Service Bulletin

January 26, 1996

"This Bulletin applies to all Models of the Indy 500 Game"

Figure 1

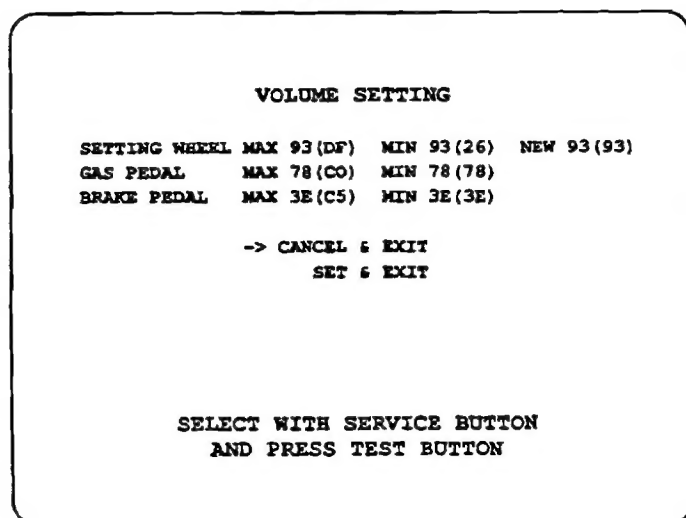
Problem : Controls do not operate properly. The Steering and Accelerator/Brake functions are not correct.

Cause : Inputs are incorrectly calibrated.

Correction : Perform the " Volume Setting " test to properly set up the player controls. Follow the procedure listed below.

1. Enter the Test Mode by pressing the Test Button located on the Service Panel inside the upper coin door.
2. Use the Service button or the View Change Buttons (Either) to move the pointer ">" to the item marked " Volume Setting ". Press the Test button to enter this area (See Figure 1).
3. Use either the Service or View change buttons to move the pointer ">" to the item marked "Set & Exit".
4. Fully Depress the Accelerator & Brake pedals one at a time. You will need to press each pedal to its' full stop, and allow it to return to its' normal "Rest" position.
5. Fully turn the Steering wheel Left & Right to each mechanical stop. Allow the Steering Wheel to return to its' normal "Rest" position. (See Figure 2).
6. Press the Test Button to store the settings and return to the Main Test Menu. Exit the menu by aligning the pointer with " Exit" and pressing the Test Button one final time.
